## Code Technology Committee Report Review of NIST WTC Recommendations Group A changes

### Review of NIST WTC Recommendations

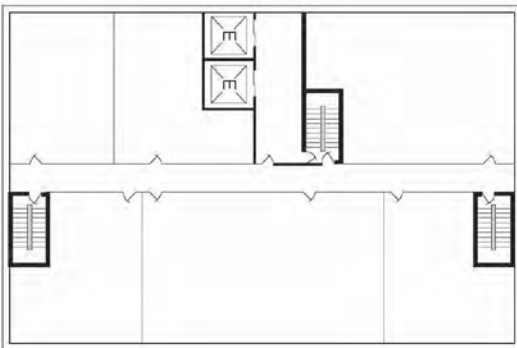
When originally submitted, the exception to Section 3007.7 gave the impression that the fire service access elevator lobby was a private dedicated elevator lobby. When G49-09/10 passed, requiring "two" fire service access elevators, it virtually guaranteed that the public lobby would be used as the fire service access lobby. This was further confirmed when G164-09/10 was passed using the following drawing:

Allowing the corridor to pass through a fire service access lobby, when properly protected, would not seem to add any extra hazard than crossing across the front of a lobby as shown in G164 above. The exception for Group I-2's and ambulatory health care needs to be evaluated.

My personal opinion is that the elevator lobby should be a separated alcove off of the side with only a corridor going across the entry way as shown in the drawing under Part I above. However, the commentary allows corridors to pass through a lobby and it allows other rooms to have direct access to and/or through the lobby. The commentary states:

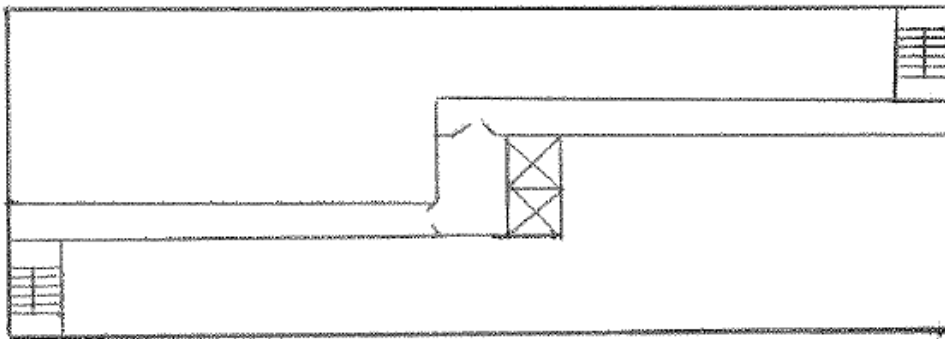
1. Corridor passes through passenger elevator lobby. If provided with access to a stair and proper construction, could this be a Fire Service Access Elevator Lobby and/or an Occupant Evacuation Elevator Lobby?

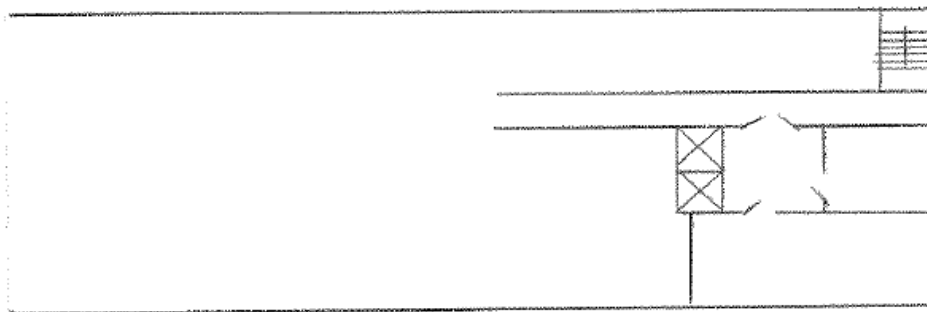
2. Rooms connect to and exit through elevator lobby. If provided with access to a stair and correct construction, could this be a Fire Service Access Elevator Lobby and/or an Occupant Evacuation Elevator Lobby?

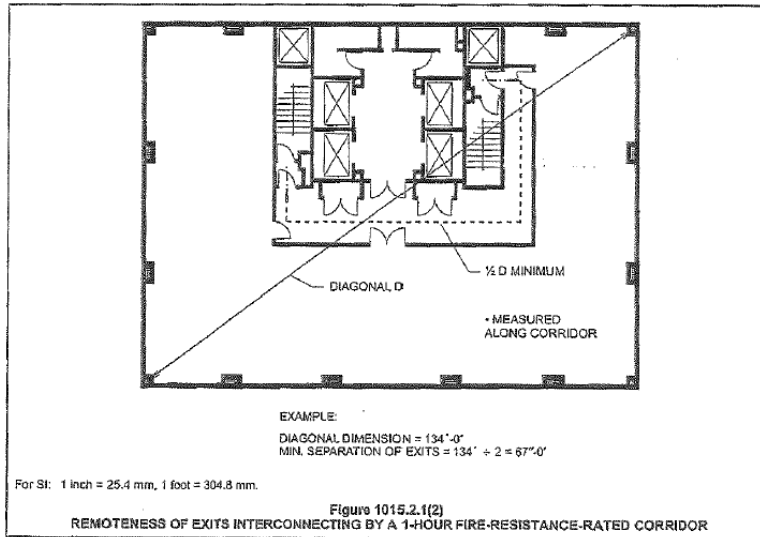
Even the commentary has an example of what appear to be restrooms off an elevator lobby as follows:

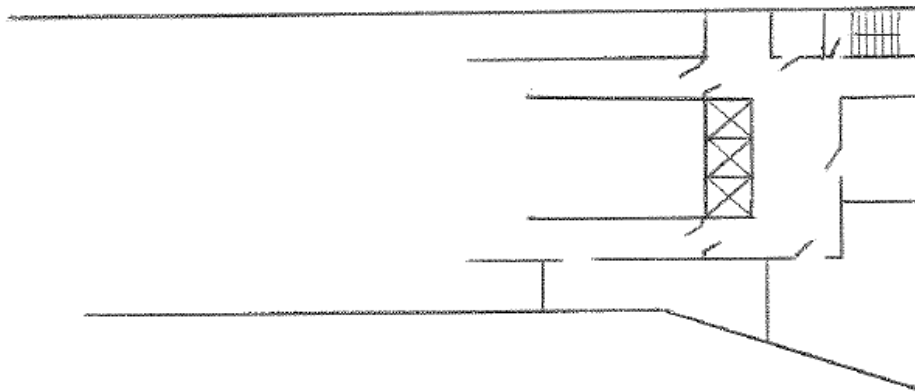
3. The following is an example of corridors passing through a lobby, along with rooms with direct connection to lobby, serving as passenger elevator lobby Fire Service Access lobby and/or Occupant Evacuation Elevator lobby. This is an actual design submitted for review.
